ADDENDUM NO. 4 PROJECT BI-CTC-455

Renovations and Addition to Lafayette Hall

Housatonic Community College

This addendum is issued to show corrections, revisions and clarifications to the BID Documents Submission for the Renovations and New Addition to Lafayette Hall at Housatonic Community College, dated March 6, 2015.

AD4-A1

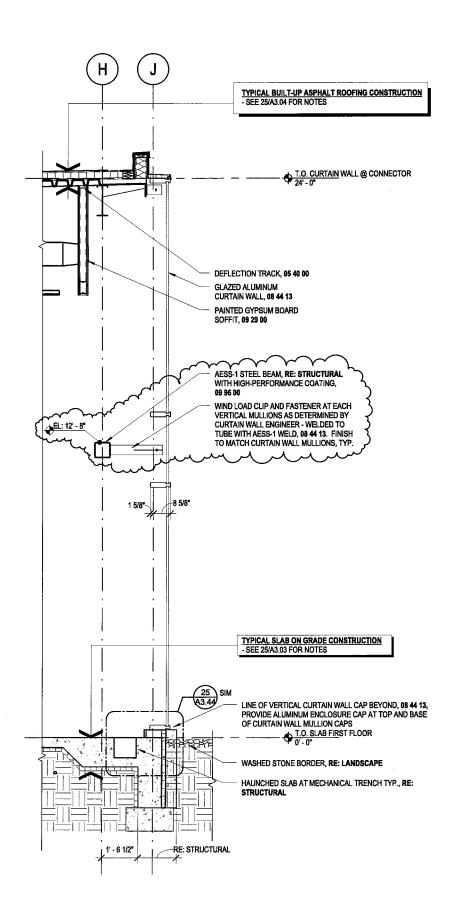
- Fireproofing Diagram 2nd Floor Framing: ADD designation 1i to beam located directly East of column line 15, columns located at gridlines G/15 and H/15 and any components of connection between beam and column.
- Fireproofing Legend: ADD note to clarify connection requirements where non-fire-resistance-rated members attach to fire-resistance rated members as indicated in sketch AD4-A1.

AD4-A2

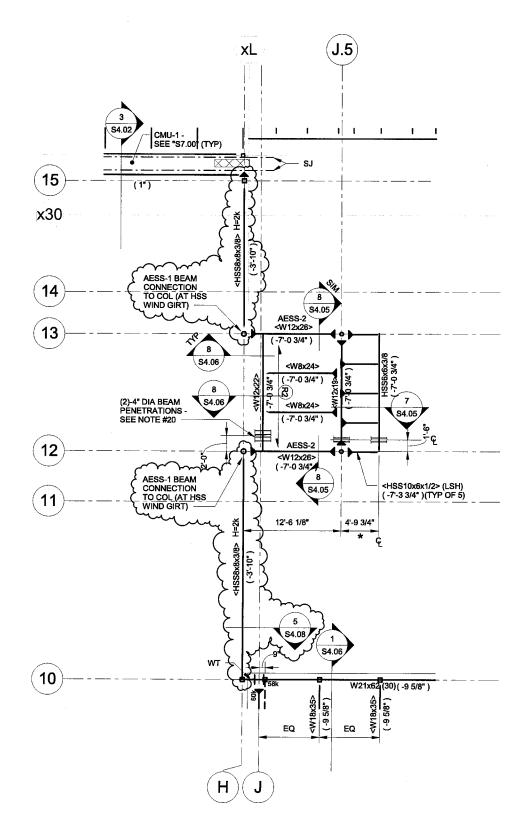
Wall Section @ Main Lobby Curtain Wall: ADD wind load clip and fastener back to added steel tube as indicated in sketch AD4-A2.

AD4-S2

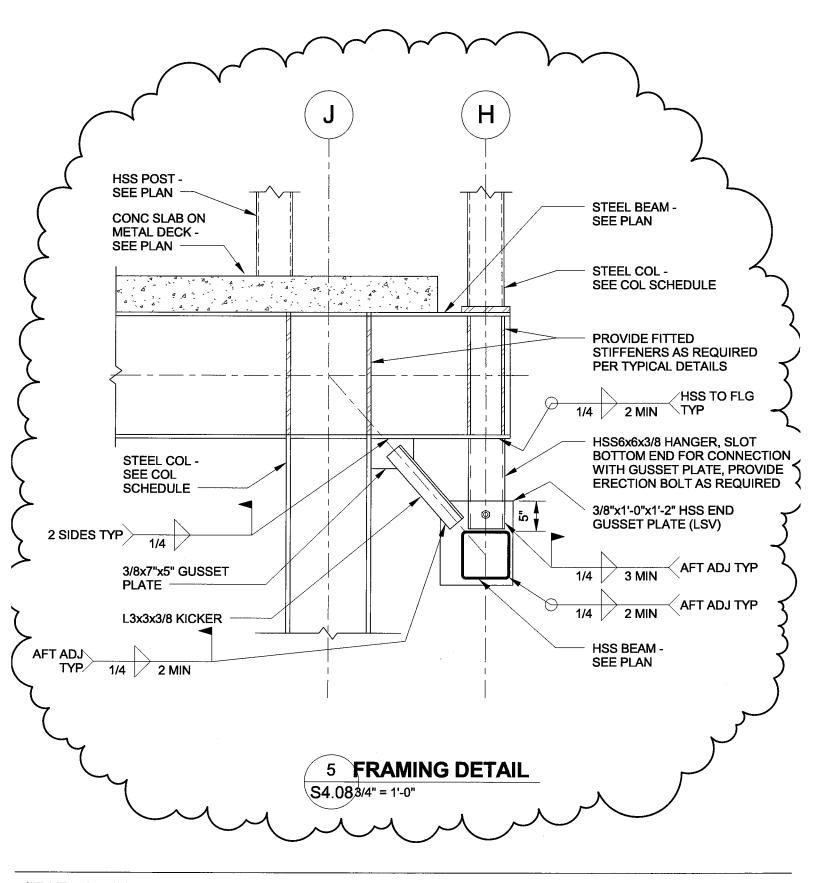
<u>Column Base Schedule:</u> REVISE column sizes as indicated in sketch AD4-S2.
